**PLATFORM ON
SUSTAINABLE FINANCE**

Response to the Complementary Delegated Act

21st January 2022

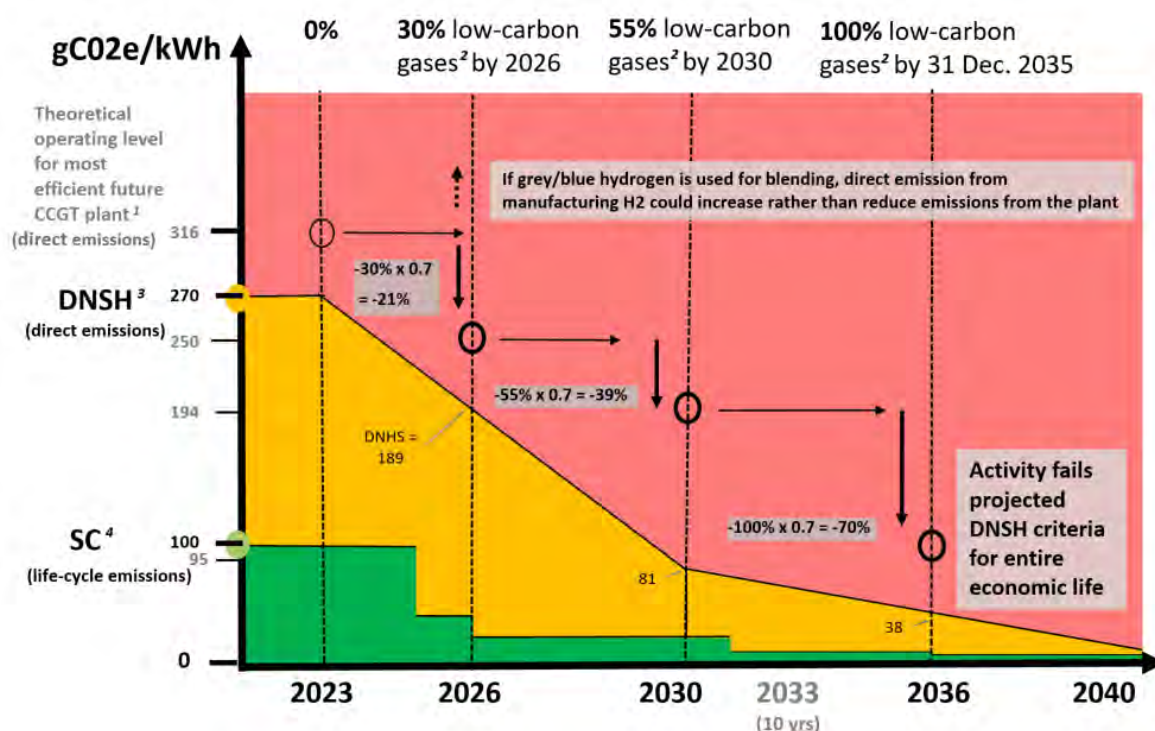
Regarding criteria 1 (b) there is high agreement that the TSCs do not constitute a substantial contribution to climate change mitigation for the economic activities under 4.29, 4.30 and 4.31 and that in fact they propose a performance level that even under conservative assumptions, will continue to fail Do No Significant Harm to the Climate Change Mitigation objective over the economic life of the activity. See Diagram 1 below.

Diagram 1 below, presenting year-on-year emissions performance of a plant and not average emissions over life-time of the asset. The analysis indicates that the draft CDA proposal for the most efficient gas-fired power known, starts and continues to fail Do No Significant Harm (Red in the chart) as it is projected, until > 10 years & is neither a Green or Intermediate Transition (“Amber” in the chart) even after 2036.

2.6. Illustrations of proposed Substantial Contribution criteria showing major inconsistency with current SC Taxonomy criteria.

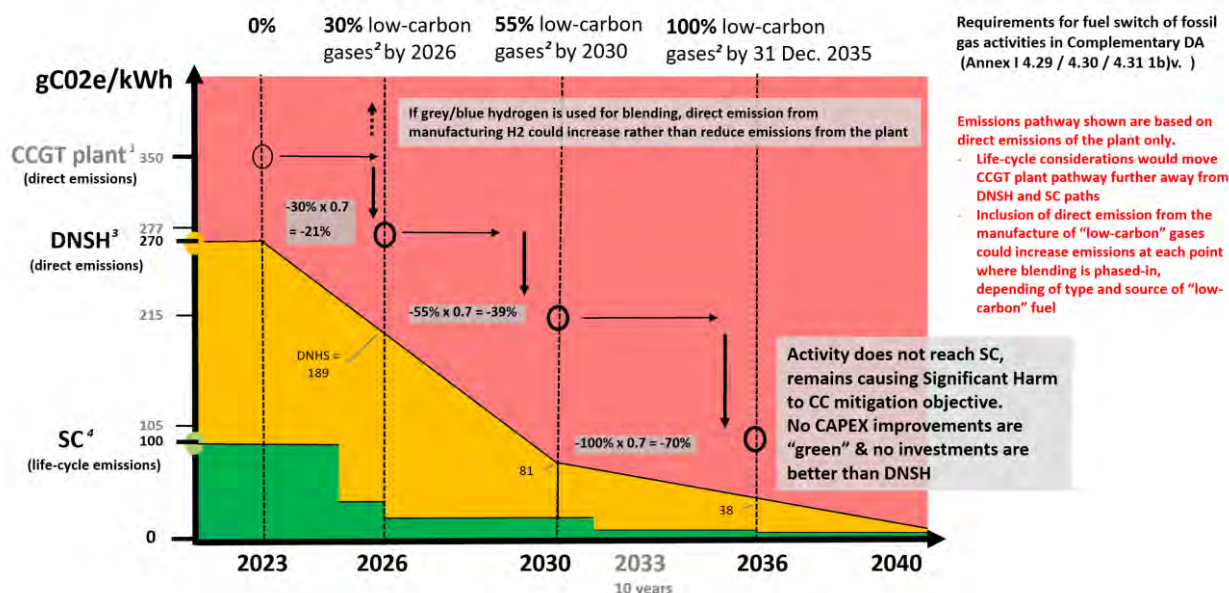
Modelling, presenting year-on-year emissions performance of a plant and not average emissions over life-time of the asset, indicates that the CDA proposal for conventional gas-fired power starts, and continues, to cause Significant Harm for > 10 years & is neither a Green nor Intermediate Transition even after 2036 (meaning performance better than DNSH improving to stay below projected DNSH).

Reporting: The whole activity/asset/plant is not Green at any point in its life when compared with existing and projected SC criteria; and no improvement CAPEX could be reported as Green under Art 8.

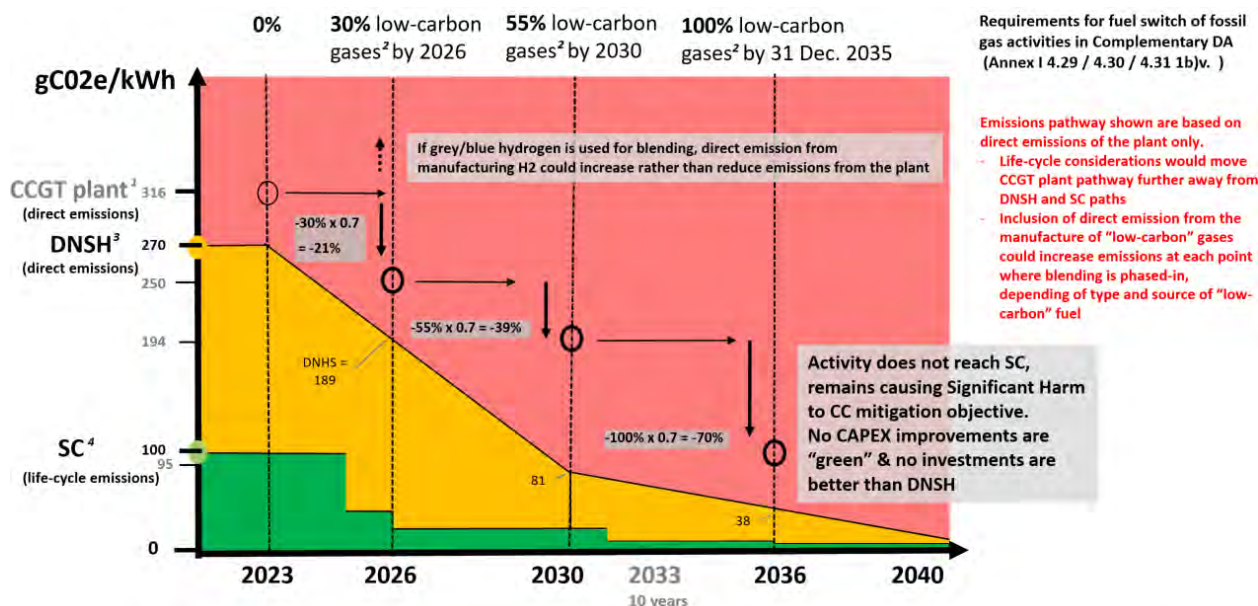
Modelling, presenting year-on-year emissions performance of a plant and not average emissions over life-time of the asset, indicates that the CDA proposal for most efficient gas-fired power known starts and continues to fail Do No Significant Harm as it is projected, until > 10 years & is neither a Green or Intermediate Transition even after 2036.

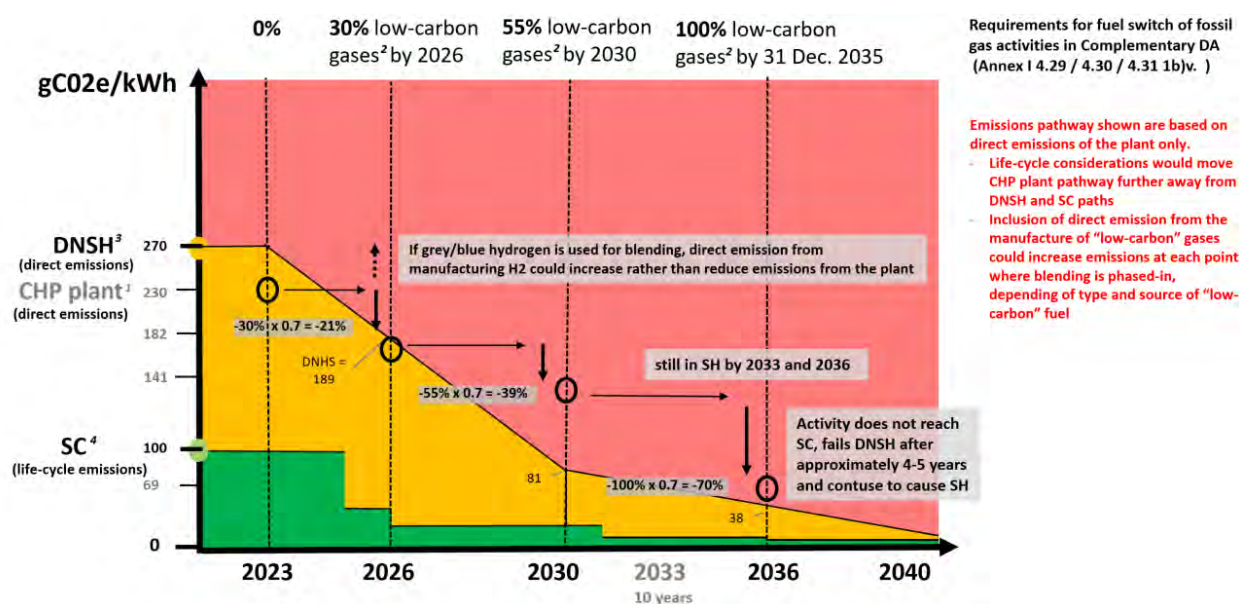
Modelling, presenting year-on-year emissions performance of a plant and not average emissions over life-time of the asset, indicates that the CDA proposal for combined-heat and power (CHPs) and district heating/cooling starts better than DNSH performance but far from SC (Green) and the transition in the proposal is not ambitious enough to avoid failing Do No Significant Harm within 5-10 years
